Authors' response

Response to all reviewers

Reviewer 1

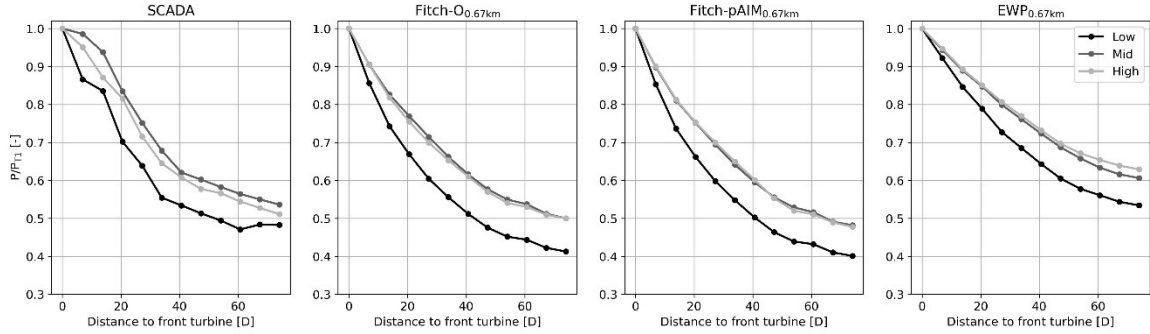
2. Atmospheric stability vs. boundary-layer structure:

Section 3.4.3 uses model PBLH as "an alternative to any stability metric" to evaluate model performance across different boundary-layer regimes. Can the authors clarify how the binning thresholds were determined and to what degree the modeled NWF PBLH is representative of the observed boundary layer structure? Because boundary-layer depth and atmospheric stability are related but distinct properties, it would also be helpful to discuss this distinction explicitly or, if feasible, corroborate the analysis using an independent stability diagnostic. Such clarification would strengthen the manuscript's conclusion that the parameterizations perform robustly across a range of atmospheric conditions.

Thanks for this comment. “any stability metric” is clearly too strong and has now been replaced with the intended “a stability metric”.

The reason for using PBLH instead of RMOL is that the latter is an instantaneous, surface layer variable that does not necessarily reflect the conditions in the rotor area. The PBLH has been shown to affect the wake recovery rate, and has therefore been chosen in this section to assess its impact on the wake magnitude. The following short clarification has been added to the text:

“It was chosen instead of the Obukhov length as it better reflects the conditions affecting the wake recovery.”

Lastly, the point about the binning thresholds is absolutely valid, as these were not based on anything other than convenience. We have now reworked this by following this paper (<https://doi.org/10.5194/wes-8-787-2023>), where the 33.3rd and 66.7th percentile was used for stability classes. This did not affect the results much, and did not affect the interpretation of these results.

“Three discrete classes were considered, separated by the 33.3rd and 66.7th percentiles (following Baas et al., 2023) of the h_{BL} in the results of the WRF simulation without turbines after filtering for the wind speed and direction considered here: Low ($h_{BL} < 616$ m), Mid ($616 < h_{BL} < 943$ m) and High ($h_{BL} > 943$ m) boundary layers.”

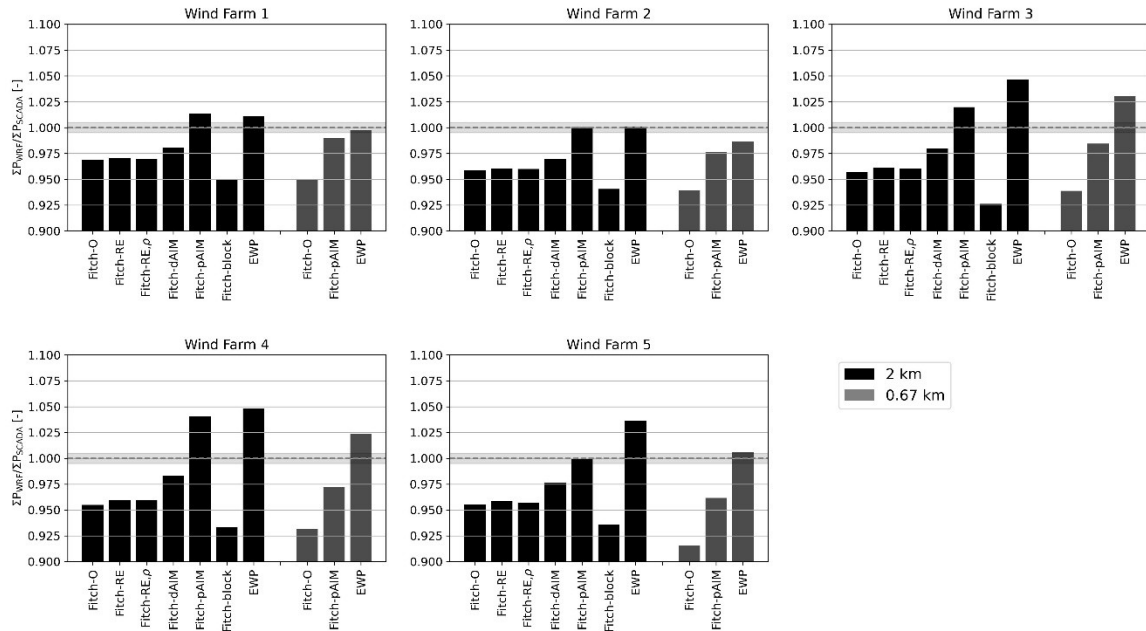
1. When wake models are validated with SCADA, it is common to filter the SCADA for time intervals where turbines are curtailed, boosted, or not operating normally. When a limited (raw) SCADA set is available, as is often the case in scientific validation studies, the remaining filtered SCADA set may become too small in order to perform a statistically valid validation. It is likely, that the authors have recognized this limitation and then chose to perform an alternative approach by replacing these data points with expected power values obtained from the manufacturer's power curve and ERA5 wind speed values. As a result, the proposed SCADA now includes data points obtained from a model and one could argue that the comparison of gap-filled SCADA with wind farm parametrization is a model-to-model comparison and not a validation. Therefore, I strongly recommend the authors to avoid the gap-filling procedure and perform filters instead. The authors write that the gap-filling procedure leads to a more fair comparison with SCADA, however, the filters for curtailment, downtime and non-normal operation could also be employed as a post filter to the meso-scale simulation results. If the authors prefer to keep using the gap-filling method then they should at least write how much of the data (in percentage) is filled, which could be reported as an average over all five wind farms to avoid showing potential confidential information. Another analysis could be made by showing the impact of the gap-filling procedure on a SCADA set where the gap-filling is not required (i.e. most turbines are operating normally). One could then perform the gap-filling on a number of random turbines (so gaps are artificially made). The results with and without gap filling can then be compared.

To your last part: This is actually what we have done and written in the paper. Apparently, it has not been formulated clearly enough so we revised the last paragraph:

“On average about 15 % of the power values were replaced with the estimated power. In below-rated conditions this decreases to 10 %. Because the gap-filling method represents the main source of uncertainty of the validation data, the uncertainty of the potential power estimate was calculated using a Monte-Carlo approach. Reference periods with more than 95 % of turbines in normal operation were selected. At randomly selected time stamps, the measured wind speed was replaced by the KNN-based wind-speed estimate, and the resulting estimated power was compared with the measured power. The differences between both values were used to quantify the uncertainty associated with the potential-power estimate.

The uncertainty of the energy-yield estimate at 100 % turbine availability was calculated by multiplying the fraction of flagged periods by the uncertainty of the potential-power estimate during those periods. For instance, an uncertainty of 10 % in the estimated power during 15% of the time results in an overall uncertainty of 1.5 %. Across the wind farms considered in this study, the resulting wind-farm-level uncertainty ranged from 0.1 % to 0.5 %. Individual wind-farm uncertainties are not reported for confidentiality reasons.”
